GUIDANCE FOR THE SURVEY AND CONSTRUCTION OF STEEL SHIPS

Navigation Bridge Visibility

2015 AMENDMENT NO.1

Notice No.33 8th May 2015

Fig. W2.1.4-1

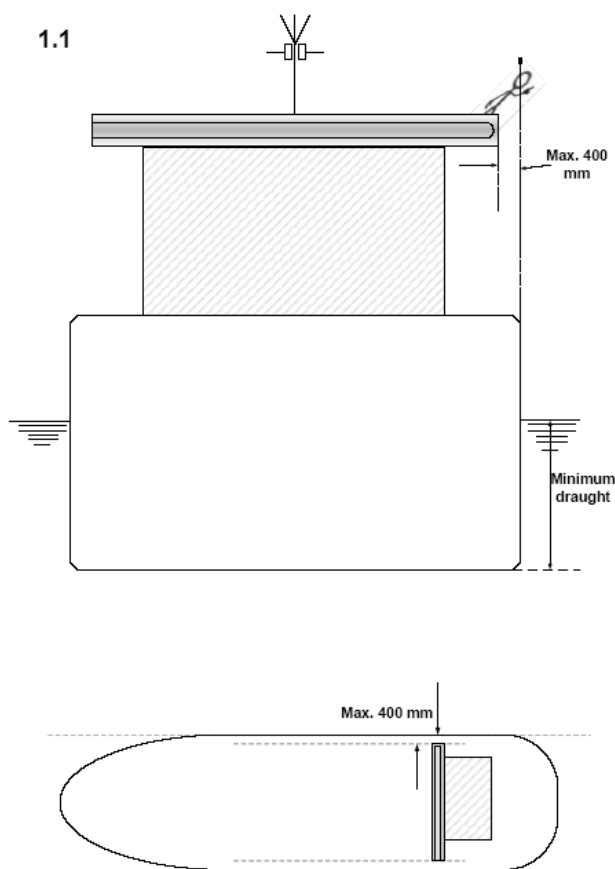
- (1) The ship’s side is to be visible from the bridge wing plus a distance corresponding to a reasonable and safe distance of a seafarer leaning out over the side of the bridge wing, which is not to be more than 400 *mm*, to the location vertically right under the maximum beam of the ship at the lowest seagoing draught. (see **Fig. W2.1.4-1**)

Fig. W2.1.4-2

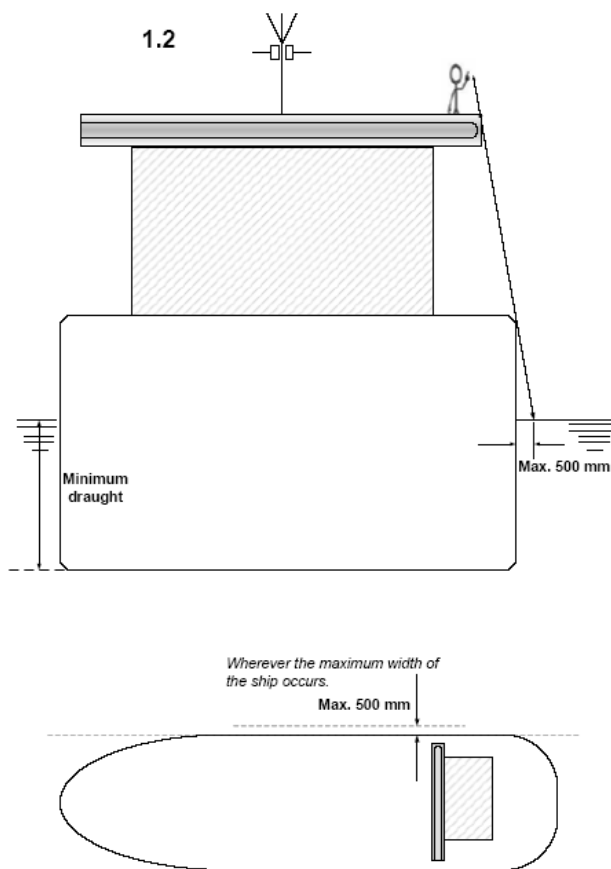
- (2) The sea surface is to be visible from the side of the bridge wing at the lowest seagoing draught and with a transverse distance of 500 *mm* and more from the maximum beam throughout the ship’s length. (See **Fig. W2.1.4-2**) However, for ships ~~such as~~ (for example, tugs/tow boats, offshore supply vessels, rescue ships and work ships (e.g., floating cranes)) that are designed such that in normal operations, they come along side or operate in close proximity to other ships or offshore structures at sea, the sea surface is to be visible from the side of the bridge wing at the lowest seagoing draught and with a transverse distance of 1,500 *mm* and more from the maximum beam throughout the ship’s length.
